610.17533-L01-v2.2.docx

# Concrete Batch Plant NIA, Glebe Island Noise Impact Assessment (SSD 8544) Response to EPA Noise Submission

The EPA provided comments to the NIA (EPA reference DOC18/21/217489) and attached to this letter are the issues raised by the EPA (shown in *italic*), with the associated response presented thereafter.

Operating Noise Levels
Daytime
Assessment at 1.5m above ground

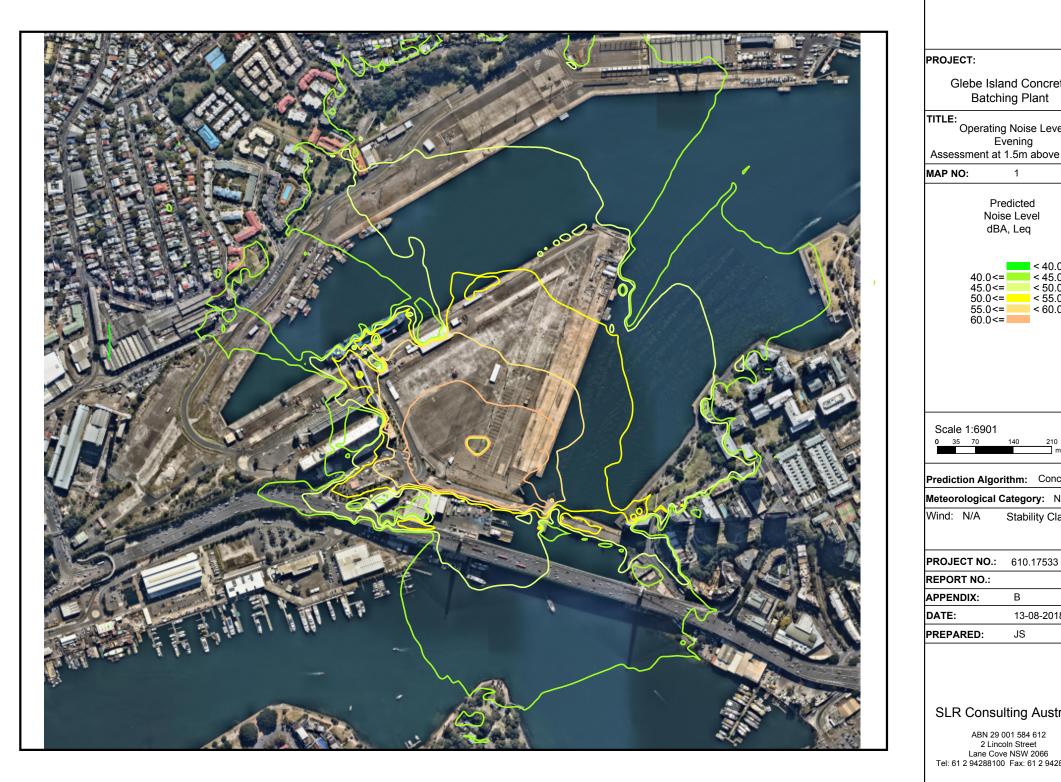
(d) clarify the modelled scenarios by providing noise contour maps of all scenarios in the NIA clearly showing the location of noise sources, buildings, structures, terrain, and receivers.

NIA Figure 3 presents proposed Facility layout, NIA Table 13 lists the major items of stationary plant (and mobile equipment) and the associated SWLs for the Facility, and NIA Table 12 describes the Facility (daytime, evening and night-time) noise modelling scenarios. The predicted operating intrusive LAeq(15minute) noise levels from the Facility's three operating scenarios are present in NIA Table 18, the associated noise contours for daytime, evening and night-time are shown in Attachment C.
